<b>CITY OF WESTMINSTER</b>			
<b>PLANNING APPLICATIONS COMMITTEE</b>	<b>Date</b> 23 February 2016	<b>Classification</b> For General Release	
<b>Report of</b> Director of Planning		<b>Ward(s) involved</b> Knightsbridge And Belgravia	
<b>Subject of Report</b>	<b>3-11 Lancelot Place, London, SW7 1DR</b>		
<b>Proposal</b>	Demolition and redevelopment of Nos. 3-11 Lancelot Place to provide five single family dwellinghouses (Class C3) comprising two basement levels (plus sub-basement plant room), ground, first and second floor levels.		
<b>Agent</b>	Savills		
<b>On behalf of</b>	High Point Estates Ltd		
<b>Registered Number</b>	15/10163/FULL	<b>Date amended/ completed</b>	30 October 2015
<b>Date Application Received</b>	30 October 2015		
<b>Historic Building Grade</b>	Unlisted		
<b>Conservation Area</b>	Adjacent to Knightsbridge

Permission is sought for the complete demolition of the existing dwelling houses and for the erection of five replacement dwelling houses comprising a sub-basement plant room, two basement levels, ground and two upper floors.

Proposed south elevation

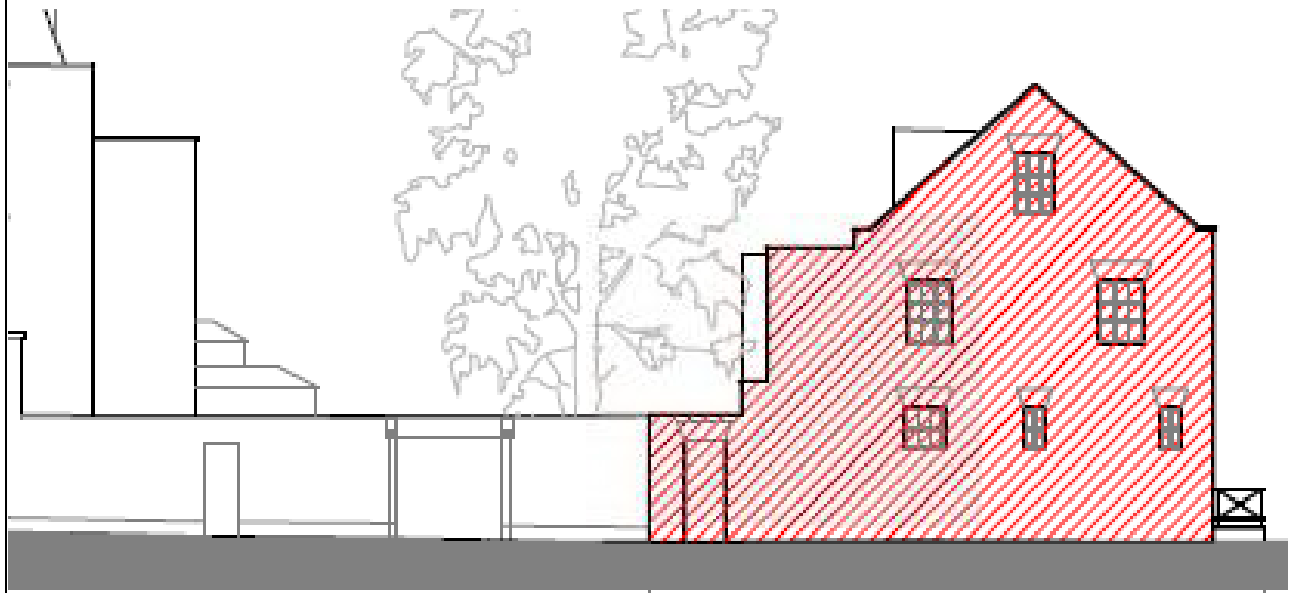
The designs of the flank elevation and roof form to the southern end of the proposed terrace (fronting the junction with Trevor Square) are similarly unresolved. The blind windows are considered to be oversized and excessive in number, with an odd inclusion of small lancet windows at first and second floor levels. An amending condition is proposed to deal with this.

Meanwhile, the roof is an awkward compromise between a traditional mansard roof form (which otherwise characterises the proposed design) and a traditional double-pitched

gable end. However this does not in itself cause it to be poor design or cause harm to the neighbouring listed buildings or conservation area.

- 16 You must apply to us for approval of detailed drawings showing the following alteration(s) to the scheme:
- (a) revised design of dormers to be amended to metal-clad (not reconstituted stone);
  - (b) revised design of south elevation, to omit window blanks from ground floor level, and improve design of inset lancet windows to first and second floors.
